ADDENDUM

ADDENDUM NO.: 01
PROJECT NAME: Sheridan Elementary School Annex
PROJECT NO.: 05075
CONTRACT NO.: C1581
DATE OF ISSUE: September 1, 2017

NOTICE OF CHANGES, MODIFICATIONS, OR CLARIFICATIONS TO CONTRACT DOCUMENTS

01 FIRST FLOOR FINISH ANNEX PLAN
SCALE: 1/8" = 1'-0"

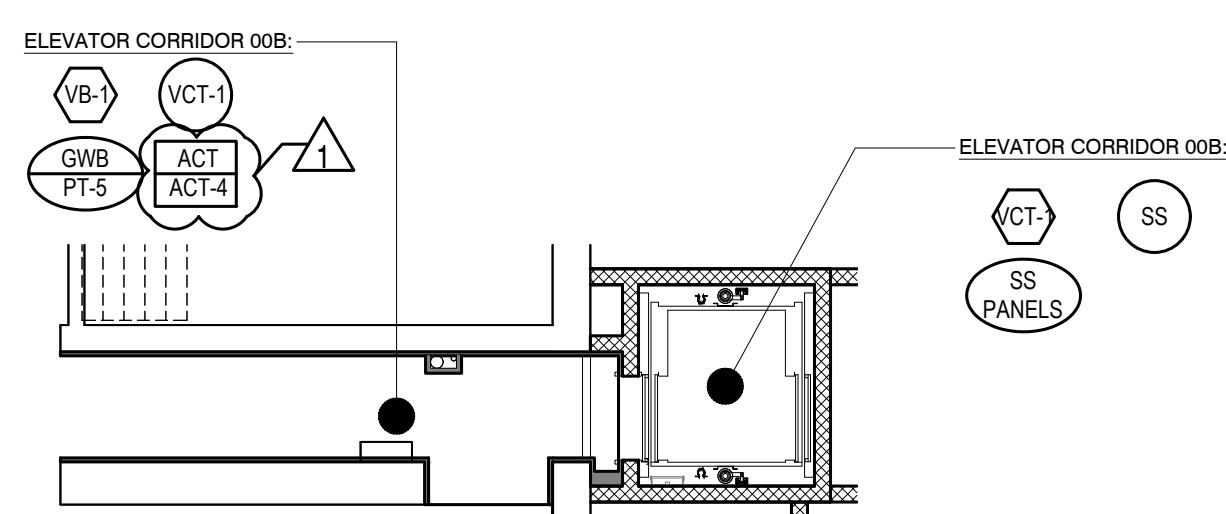
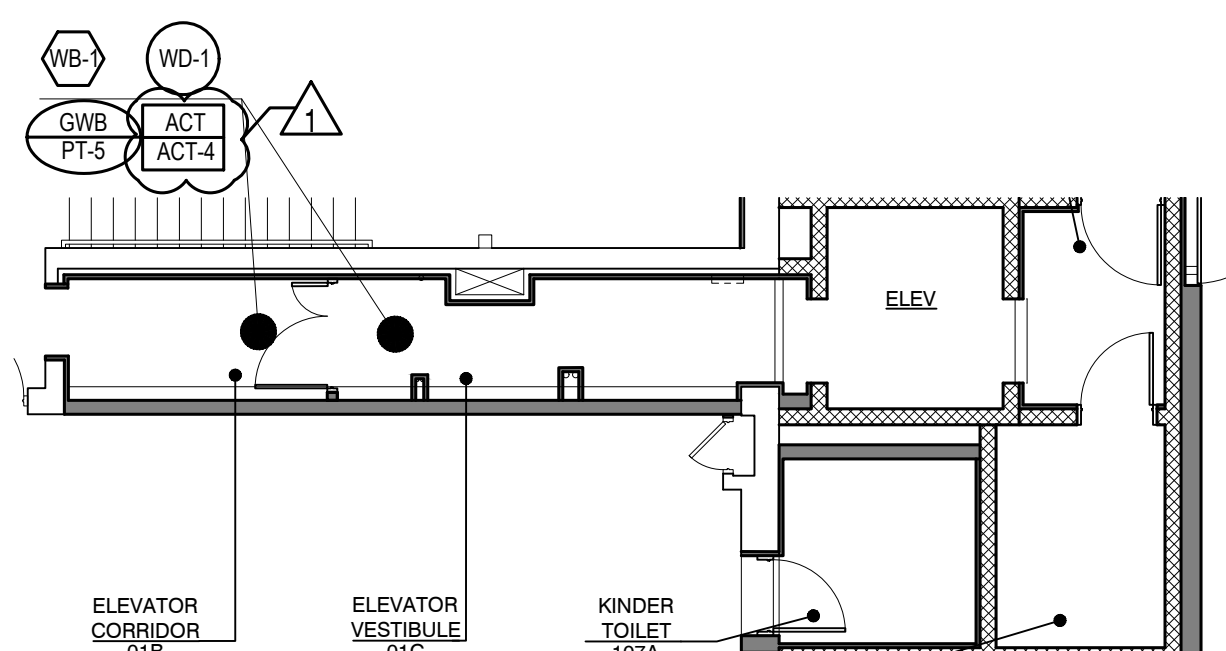
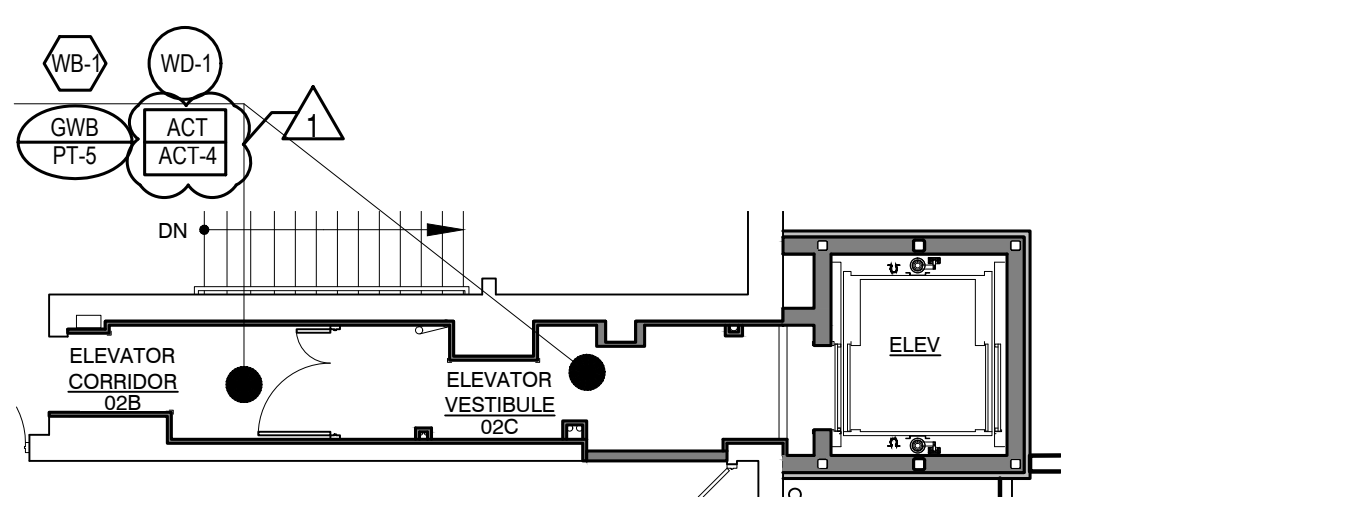
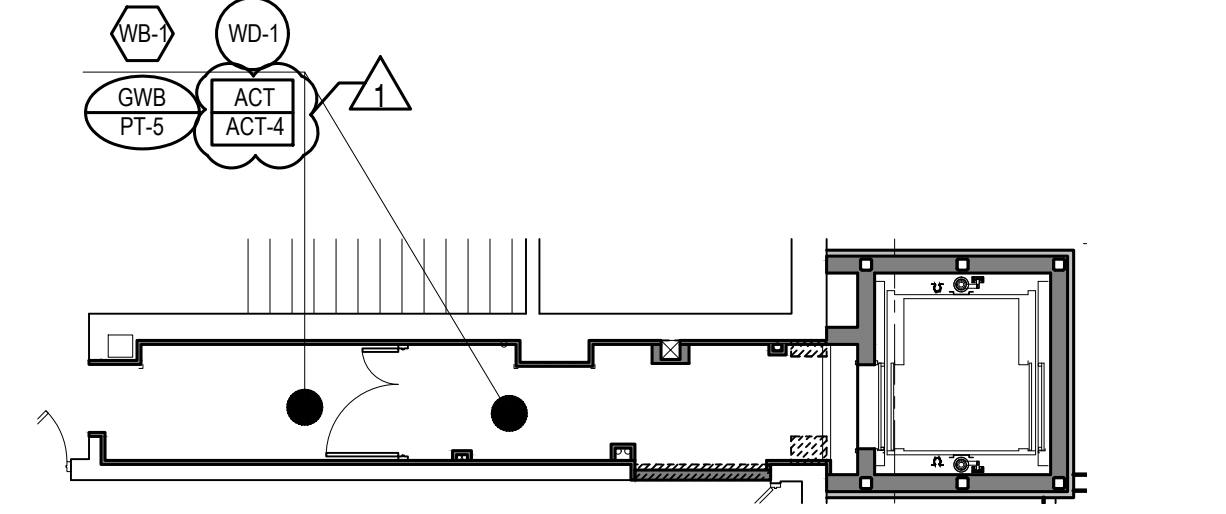
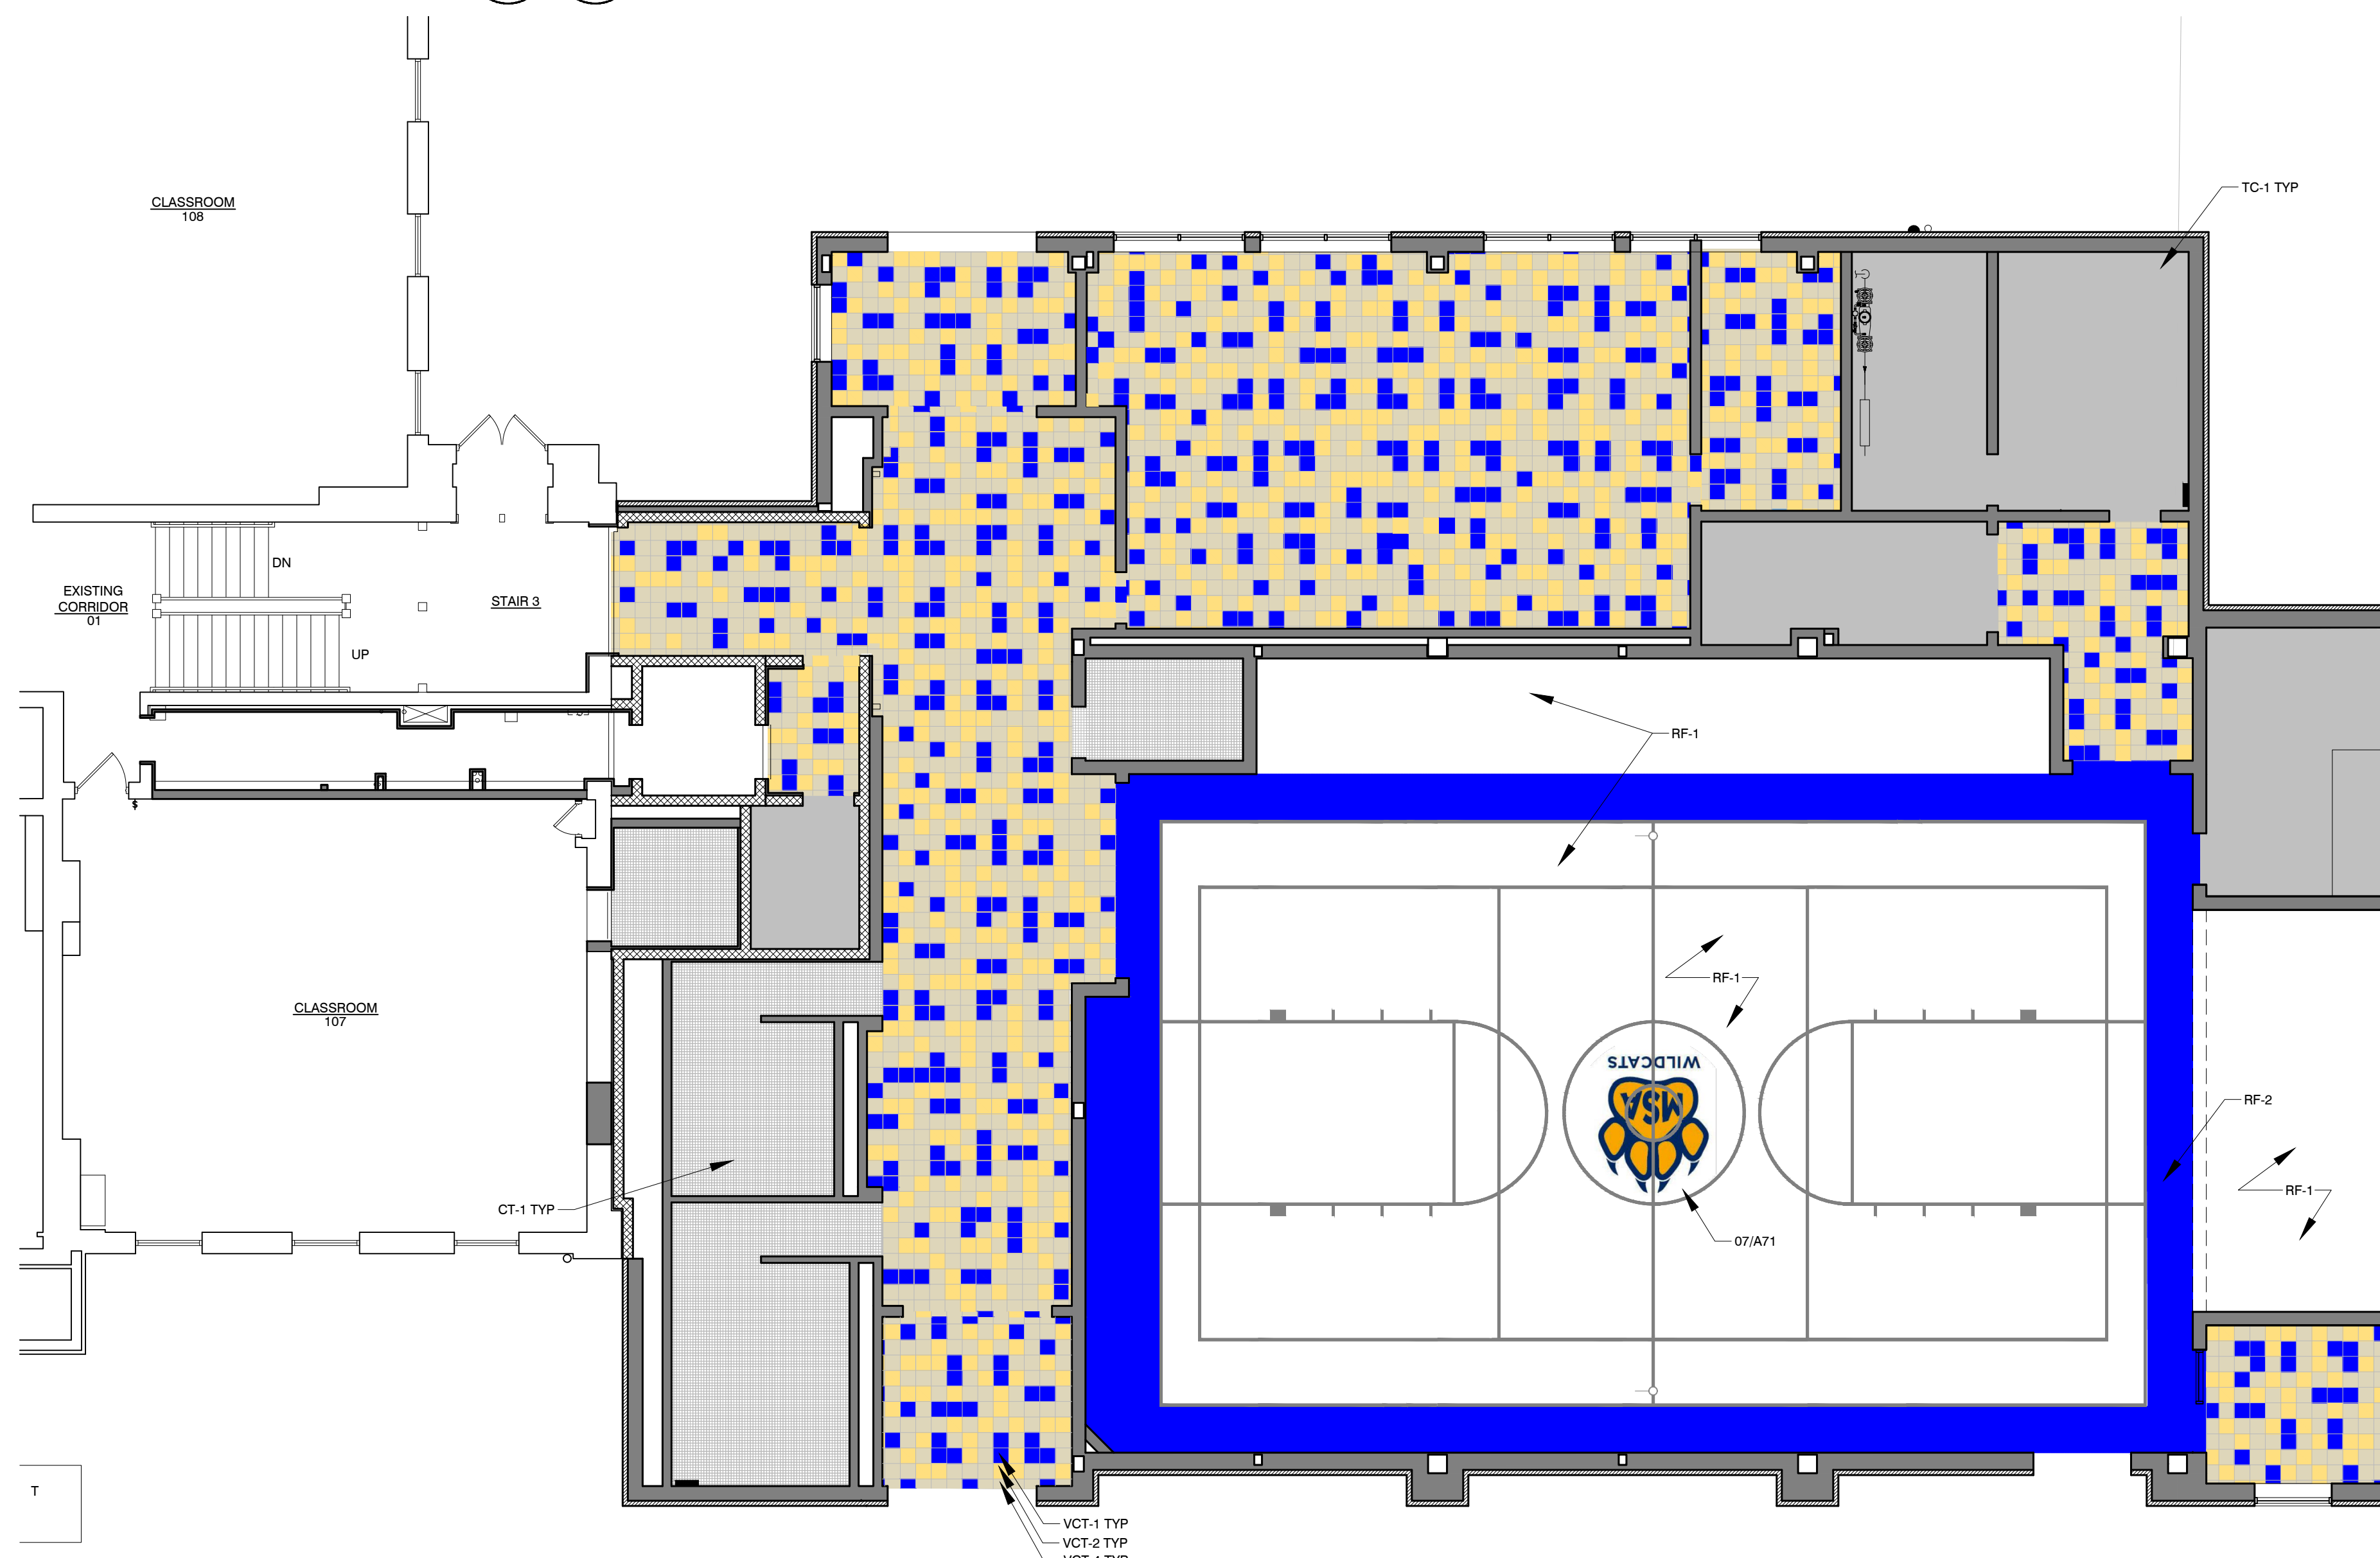
- Change 12. REVISED** – Drawing No. A71 – FIRST FLOOR FINISH PLAN: Revised ACT type from ACT “1” to ACT “4” in details 03, 04, 05 and 06. Enlarged elevator plans to match Finish schedule.
